Product Change Notification / RMES-14WQGP950

CCB 5301 Initial Notice: Qualification of MTAI as an additional final test site for MIC210xYML device family available in 16L VQFN (3x3x1.00mm) package.

PCN #: RMES-14WQGP950

Pre and Post change comparison
PCN #: RMES-14WQGP950

Pre and Post Change Summary - Base Quantity Multiple (BQM) per reel

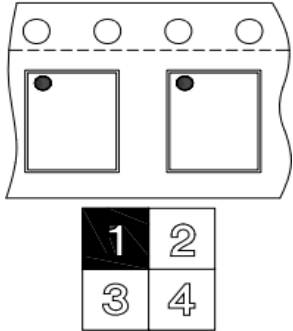
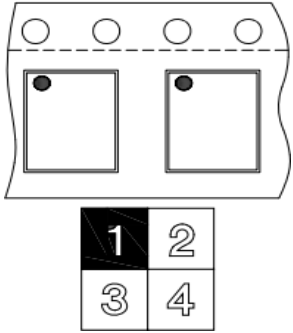
UNIS	MTAI
Units per reel: 5000	Units per reel: 5000

Pre and Post Change Summary - Carrier Tape

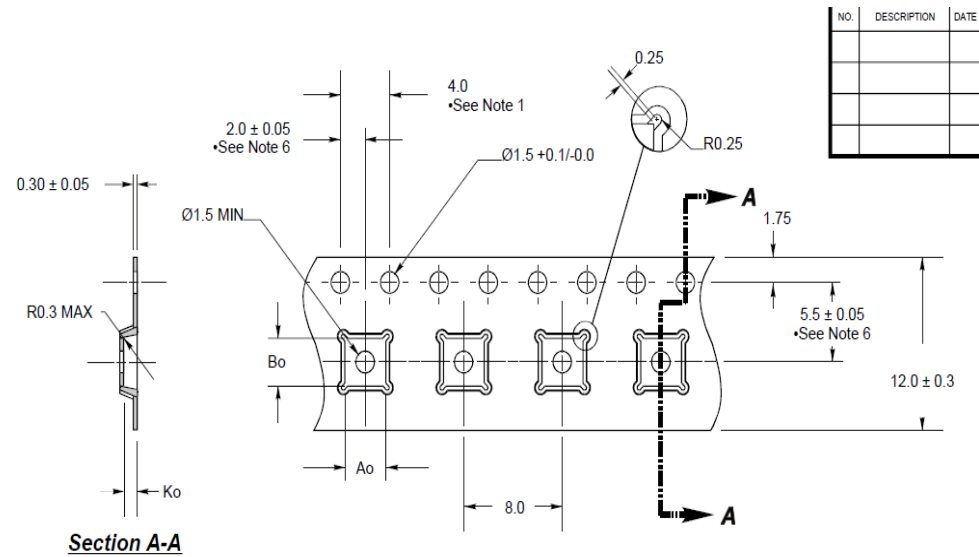
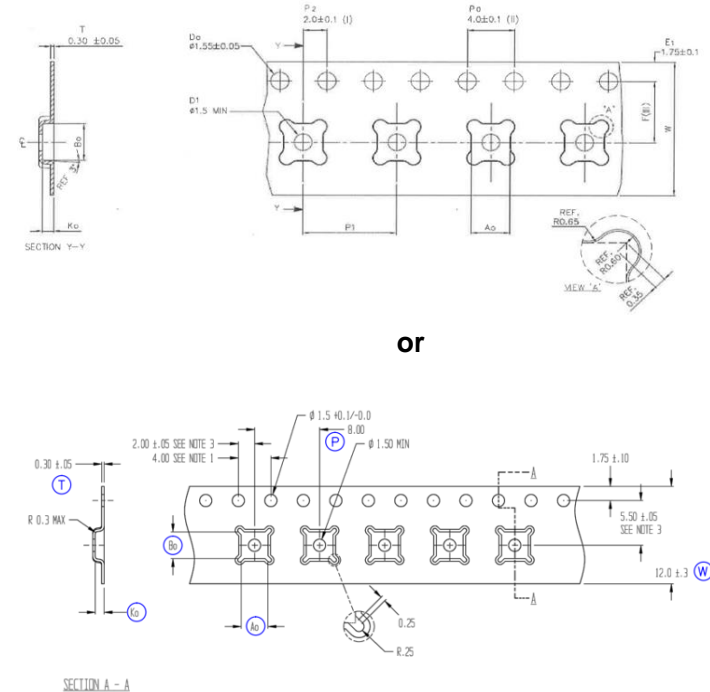
Plant	W (mm.) ± 0.3 or Specific	P (mm.) ± 0.1 or Specific	$A_0 \pm 0.1$ or Specific	$B_0 \pm 0.1$ or Specific	$K_0 \pm 0.1$ or Specific
UNIS	12mm $+0.3$	8.00mm	3.30mm	3.30mm	1.10mm
MTAI	12mm $+0.3$	8.00mm	3.30mm	3.30mm	1.10mm or 1.00mm

Pre and Post Change Summary - Cover Tape

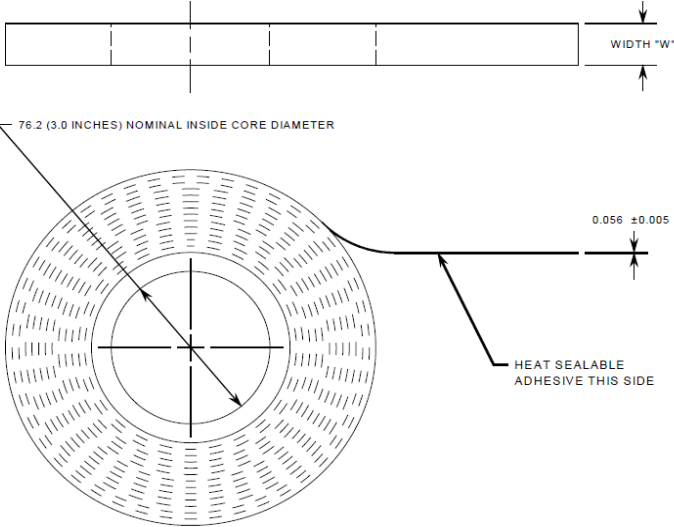
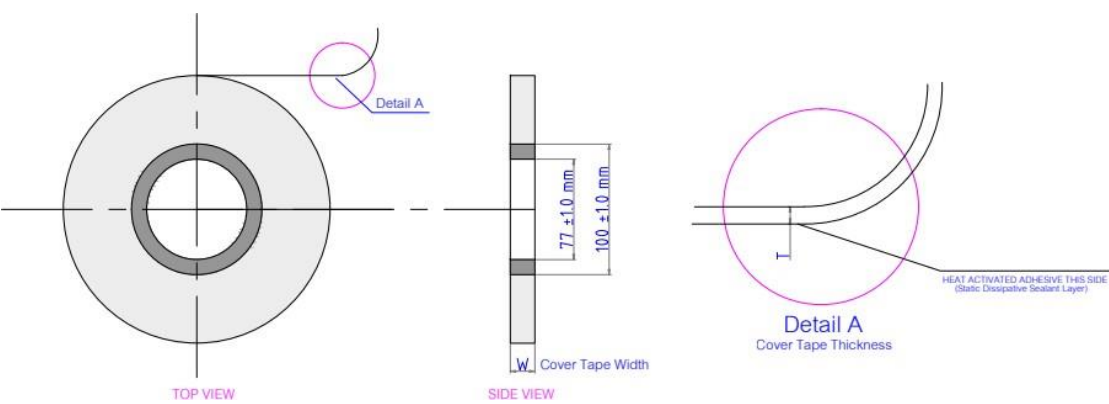
Plant	Cover Tape Width	Thickness	Color	Sealing mythology
UNIS	9.2mm	0.056mm	Clear	Heat Seal
MTAI	9.05+0.05/-0.15mm	0.050 ± 0.010mm	Clear	Heat Seal

Pre and Post Change Summary - Plastic Reel

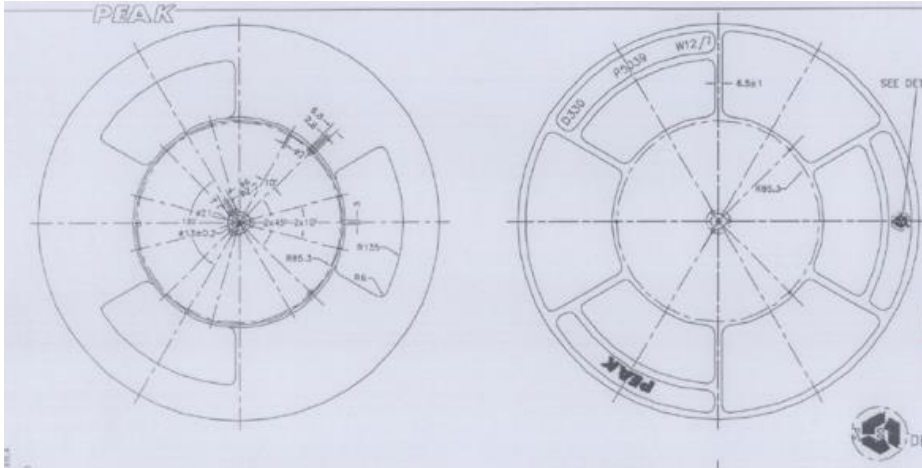
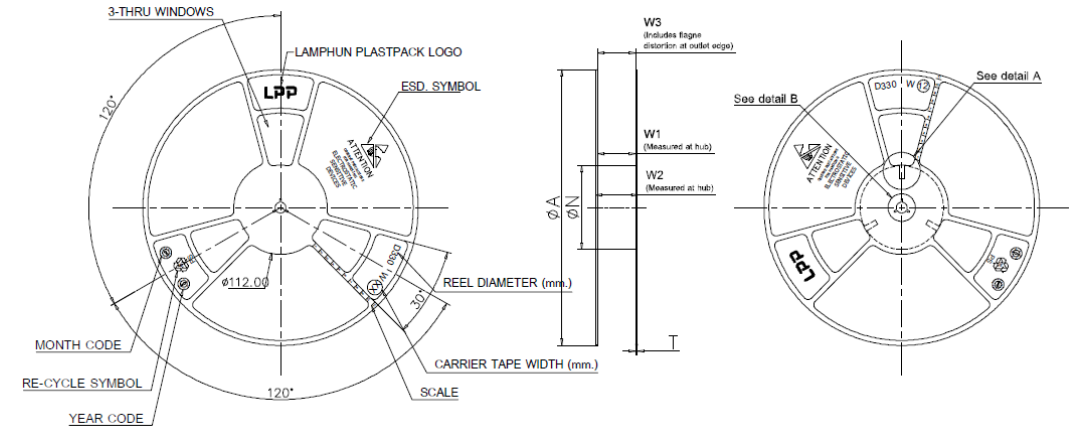
Plant	Reel diameter	Reel Hub Size (mm)	Reel Width Max (mm)	Reel Color
UNIS	330 +4.0/-0.25	177 ±2.0	18.40	White
MTAI	330 +/- 2.0	100 ±2.0	18.40	Dark Blue

Pre and Post Change Summary – Moisture Barrier Bag

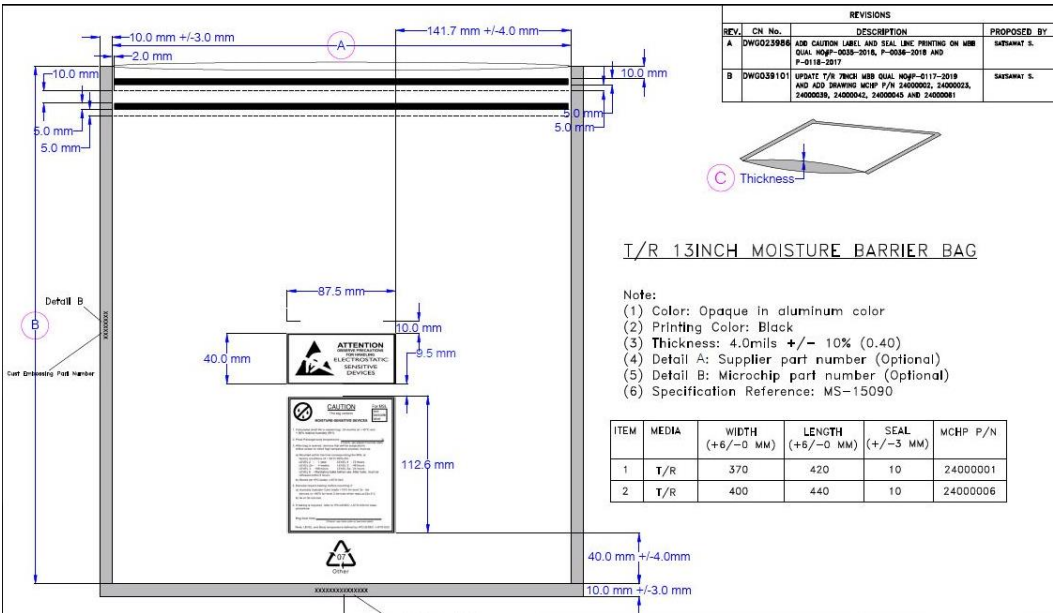
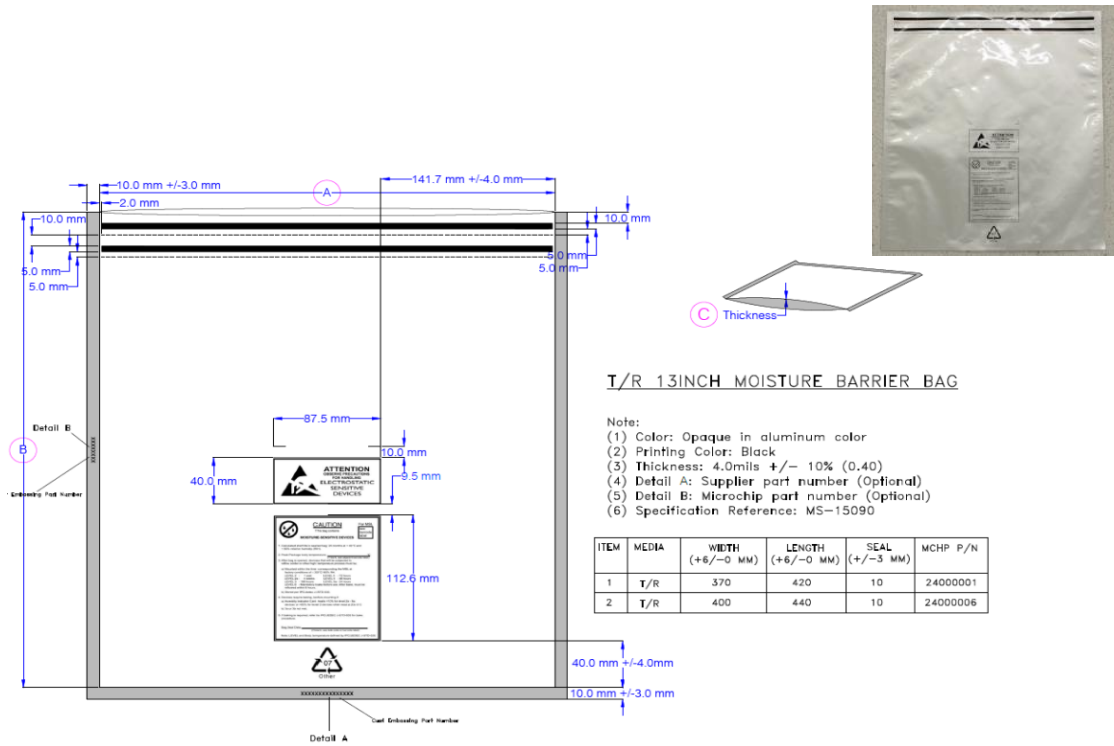
Plant	Length (Inch)	Width (Inch)	Thickness (Mils)
UNIS	16.53	14.56	4
MTAI	16.53	14.56	4

Pre and Post Change Summary – Packing Method

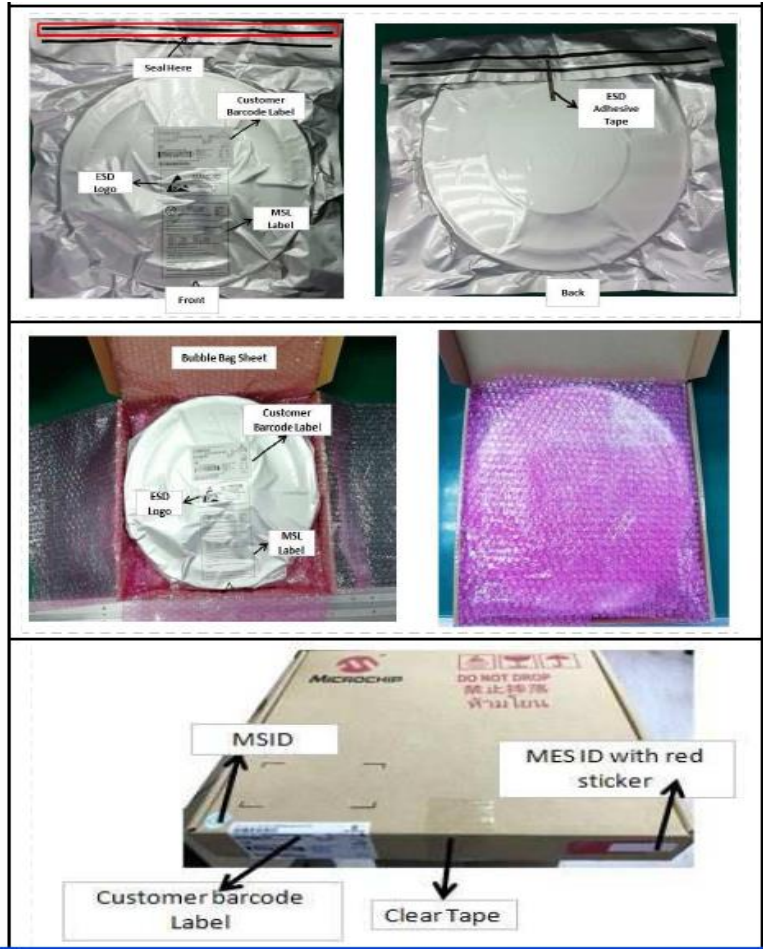
Final Test Site	Unisem (M) Berhad Perak, Malaysia (UNIS)	Unisem (M) Berhad Perak, Malaysia (UNIS)	Microchip Technology Thailand (HQ) (MTAI)
Packing Media	Tape and Reel	Tape and Reel	Tape and Reel
Base Quantity Multiple (BQM)	5000	5000	5000
Pin 1 Orientation	Q1	Q1	Q1
Carrier Tape	With minor dimensional changes. See attached pre and post change comparison		
Cover Tape	With minor dimensional changes. See attached pre and post change comparison		
Reel Color	White	White	Dark Blue
	With minor dimensional changes. See attached pre and post change comparison		
Moisture Barrier Bag	No dimensional changes. See attached pre and post change comparison		
Packing Method	See attached pre and post change comparison
